MIL-B-49450/8(ER)
AMENDMENT 2
23 July1992
SUPERSEDING
AMENDMENT 1
3 April 1987

MILITARY SPECIFICATION SHEET

BATTERY, RECHARGEABLE, NICKEL-CADMIUM, VENTED, AIRCRAFT
BB-716/A

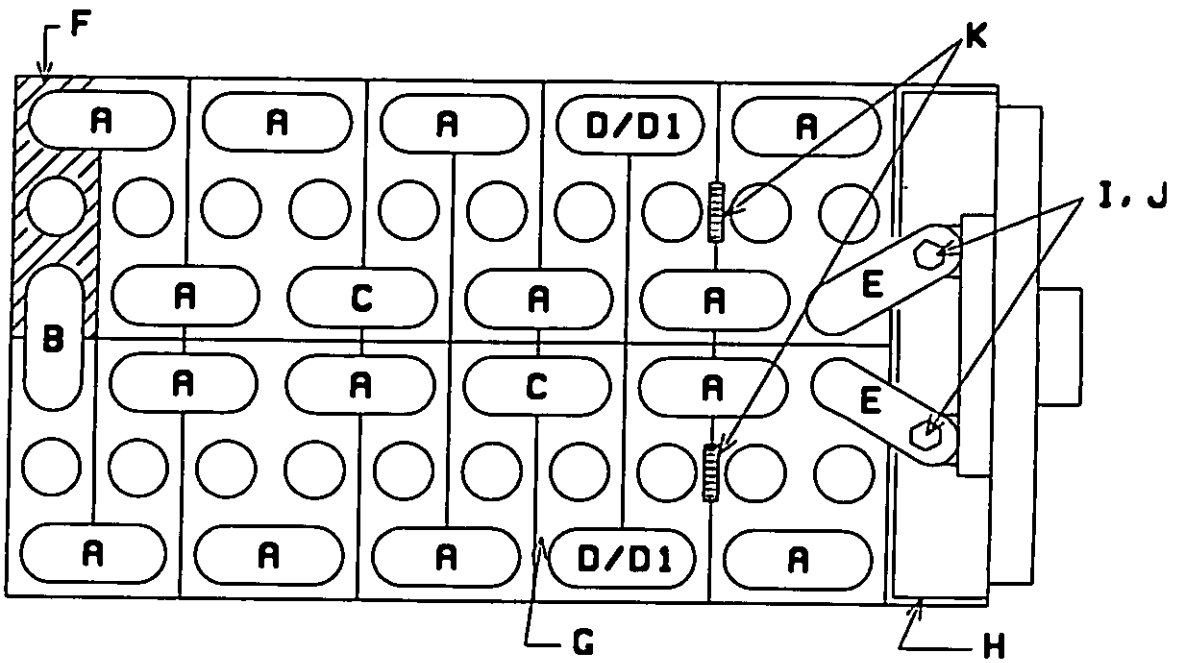
Delete Figure 3 and substitute the following:
